# **System Pillar / EULYNX**

## **Baseline Set 4 Release 2**

Version: 2.2  
Date: 17-10-2024

# Error corrections

**[EUP-516] [Req. Spec. P: Incorrect IO Flow on SD 2.1.2.4.9 \(Eu.P.5804\) and 2.1.2.4.10 \(Eu.P.5374\)](#)** Created: 10.08.2023 Updated: 10.08.2023

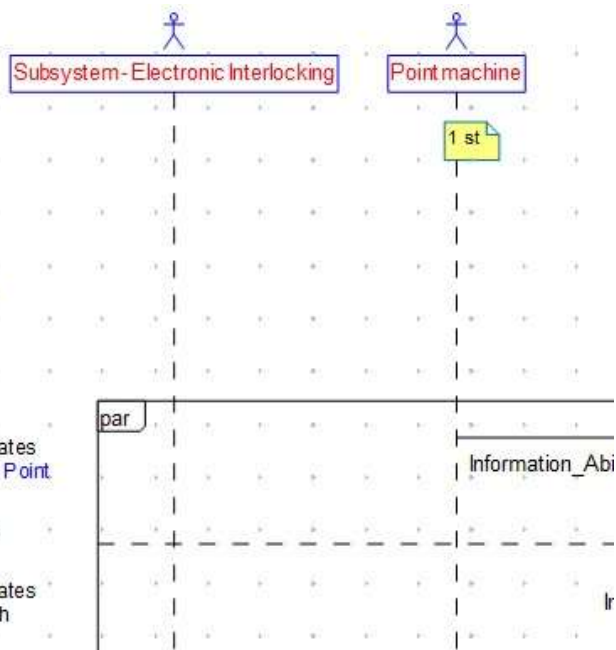
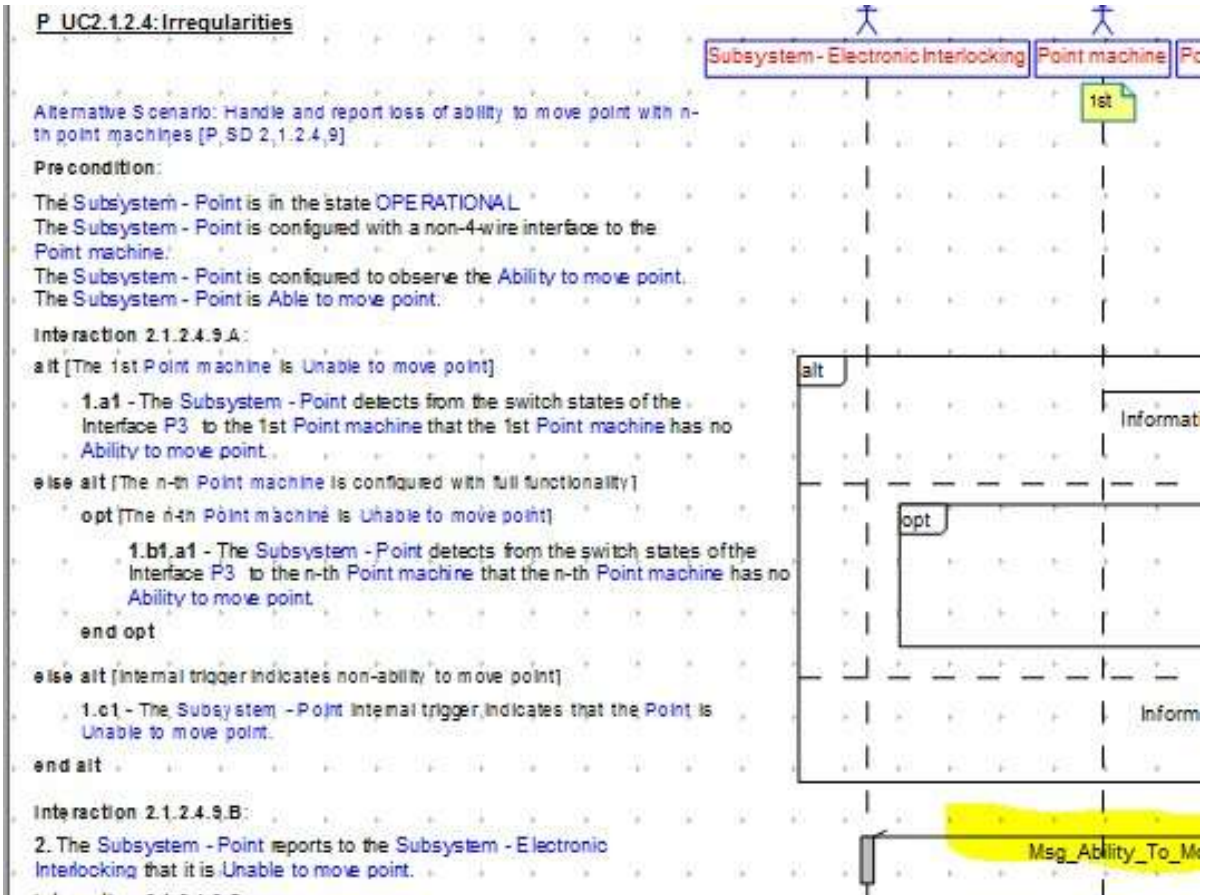
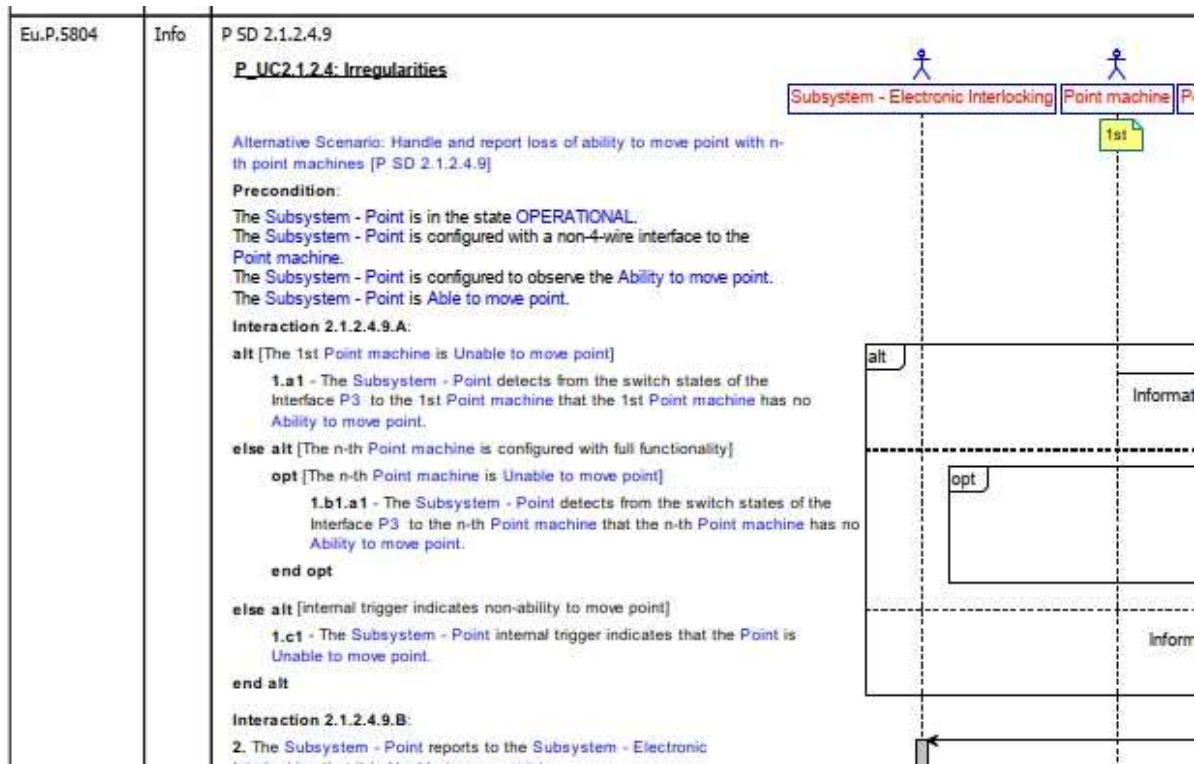
On SD 2.1.2.4.9 (Eu.P.5804) and 2.1.2.4.10 (Eu.P.5374) in on Step 2 a incorrect IO Flow is used (Msg\_Point\_Position).

Msg\_Ability\_To\_Move\_Point should be used.

image-2023-08-15-13-44-53-576.png

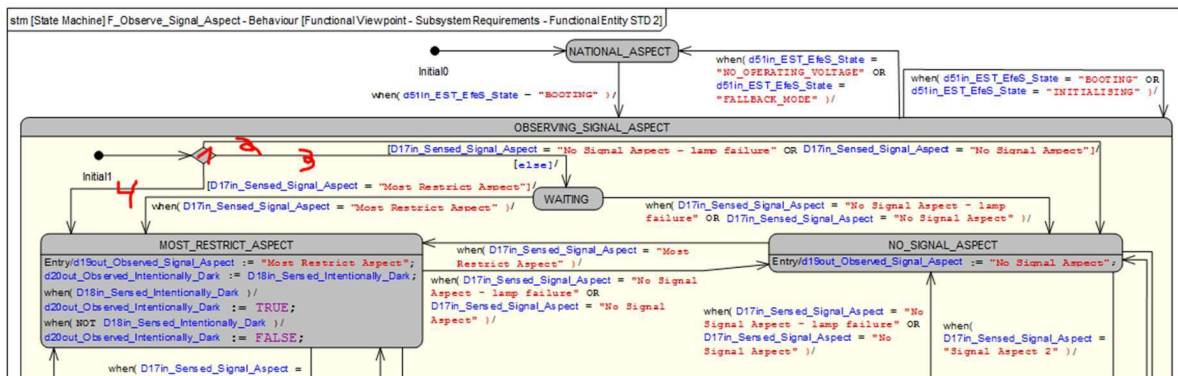
When the LS will be set from OPERATIONAL (while indicating "most restrict Aspect" back to BOOTING and then back to OPERATIONAL the controller is not able to report the newly set Aspect to the interlocking.

This is caused due to a deadlock in the observing block as it reacts just on the change trigger of D17 and can therefore not leave the state WAITING.

The STM for observe Signal Aspect shall be extended with transitions made of purely guard conditions (reacting on current state and not change trigger) as in attached pic shown. The four marked transitions/elements should be added to correct the described behaviour above.

stm [State Machine] F\_Control\_4W\_PM - Behaviour [Technical Viewpoint - Subsystem Requirements - Technical Functional Entity STD 1]

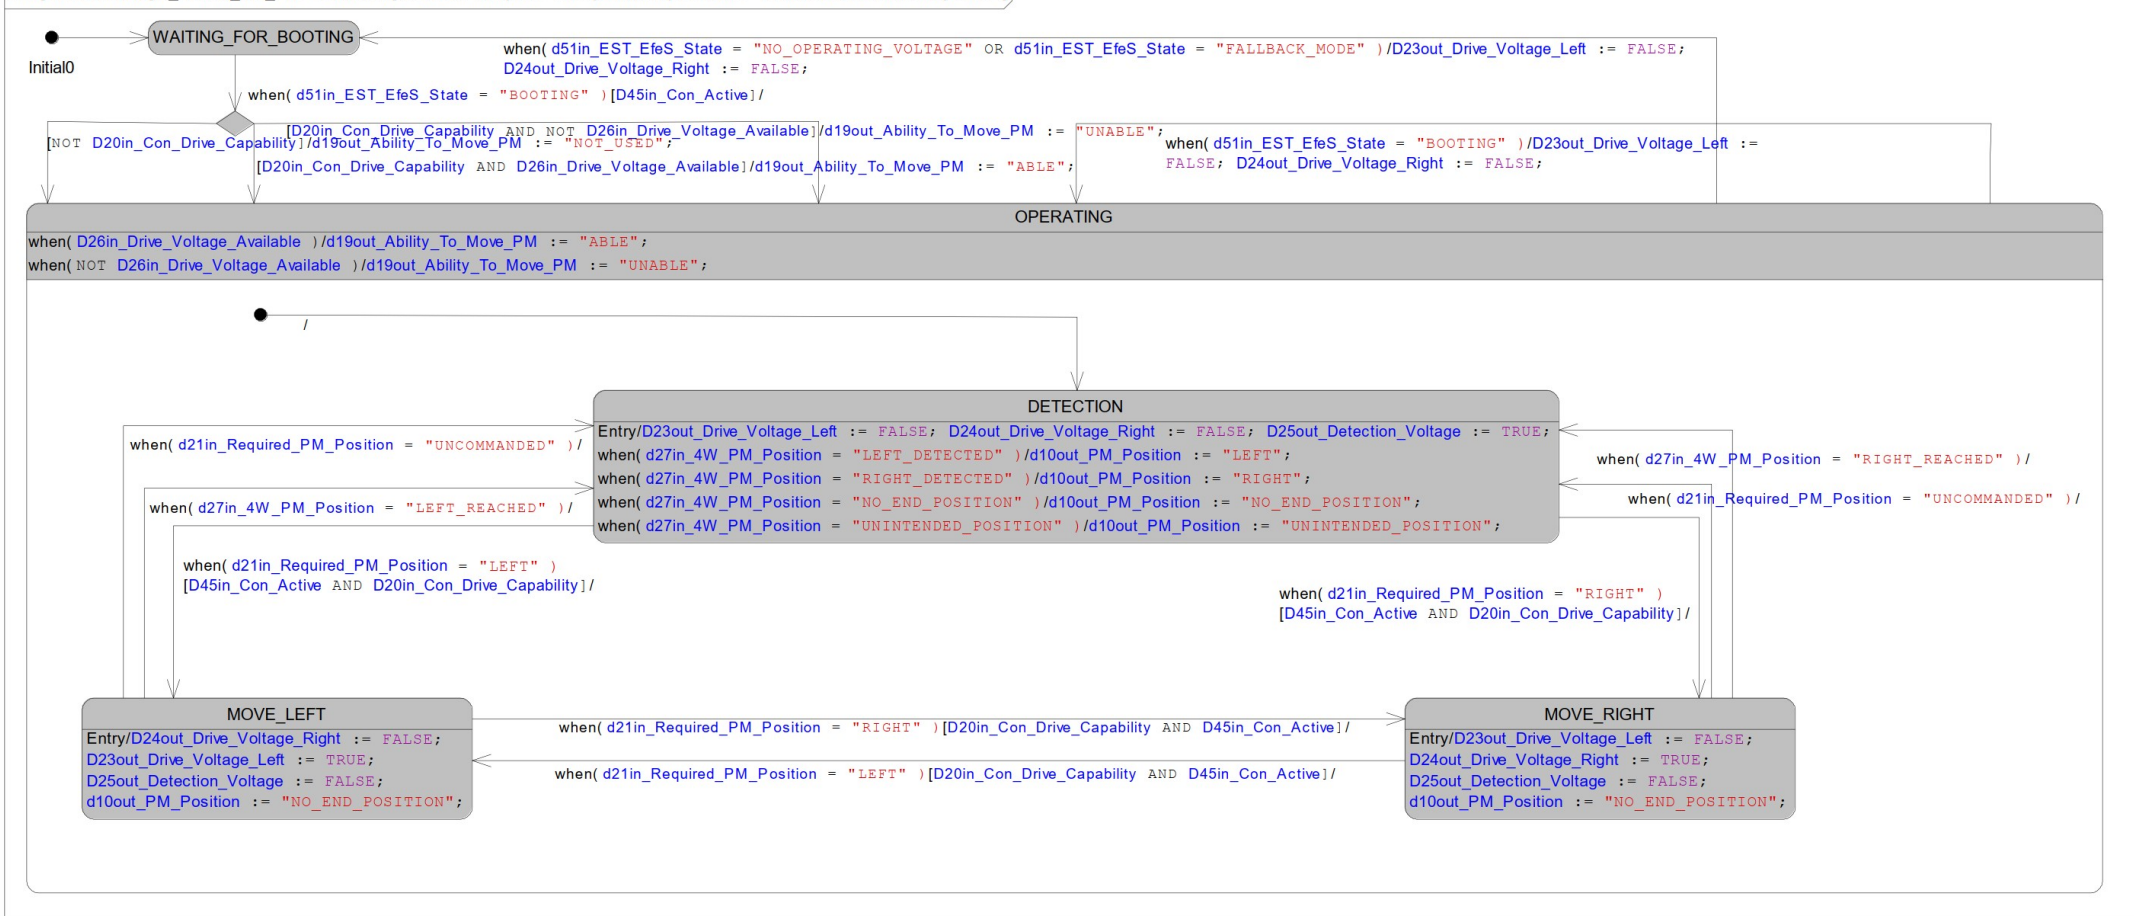
The correct transition must be `d27in_4W_PM_Position = "LEFT_REACHED" / d27in_4W_PM_Position = "RIGHT_REACHED"`.

The correct transitions are shown in the attached figure.

# F\_Observe\_Ability\_To\_Move

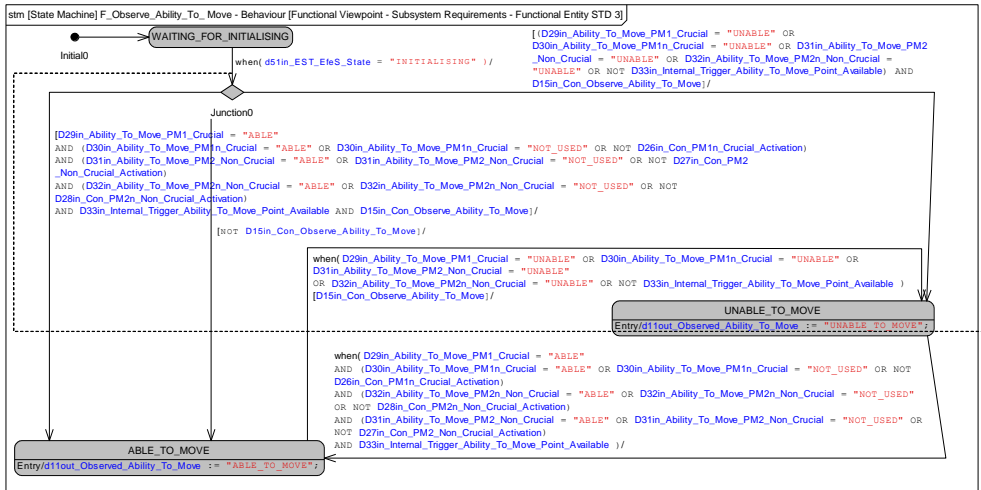
20220905 BFG: Hier muss noch geklärt werden, wann wieder in "WAITING\_FOR\_INITIALISING" zurück gegangen werden kann! Wenn all das hier nur in INITIALISING und OPERATIONAL stattfinden soll, fehlen die Rücktransitionen!
